# Product Change Notification

## 105571 - 01

**Change Notification #:** 105571 - 01  
**Change Title:** ARIGRACK, PCN 105571-01, FYI, CLASS 2: RIGGINS DESIGN IMPROVEMENTS TO 3U SLIDE RAIL  
**Date of Publication:** December 07, 2005

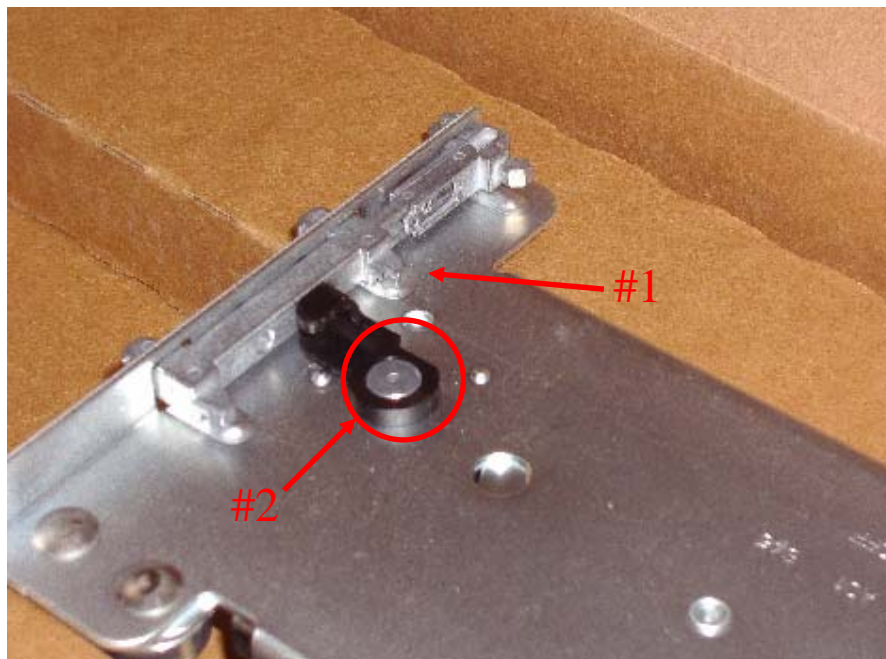
3. Material removed from this area of the plastic swing block. All swing blocks on the rails are affected. (see image below)

4. Locking tab added to the plastic sliding block. This prevents the cable management arm from disconnecting unexpectedly. (see image below)

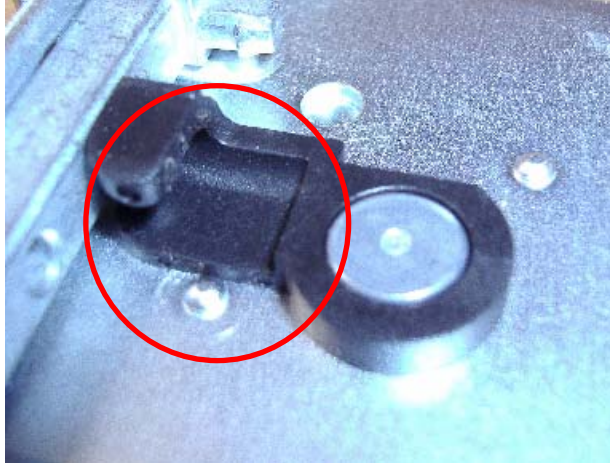
1. Three embosses added to the sheet metal (can't see in the image, they are under the multi-pin). Function is to hold the multi-pin out farther from the slide rail, which positions the slide rail correctly in a rack cabinet.
2. Plastic swing block moved in this direction to hold the multi-pin better. This was done on both the front and the back of the slide rails. (see image below for change #1 & #2)
